**Ref No ABP 313829**

**Blanchardstown to City Centre Bus Connects**

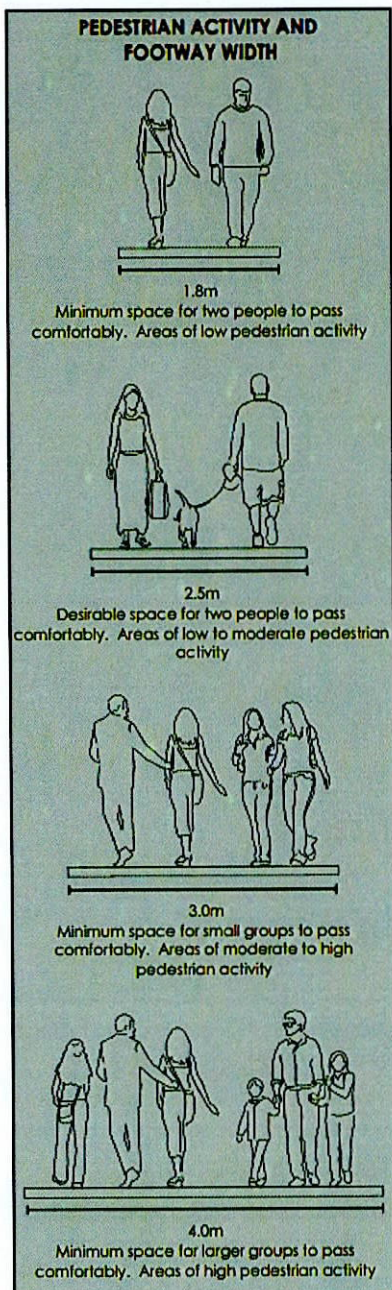
The manual references the UK *Pedestrian Comfort Guidance for London* and the associated figure below.

Accordingly, this figure clearly shows that the footpath environment at 136-142 Navan is not purely residential and is currently aligned with the third scenario for 3.0m width due the presence of the bus stop, schools and care homes. I also note the manual states:
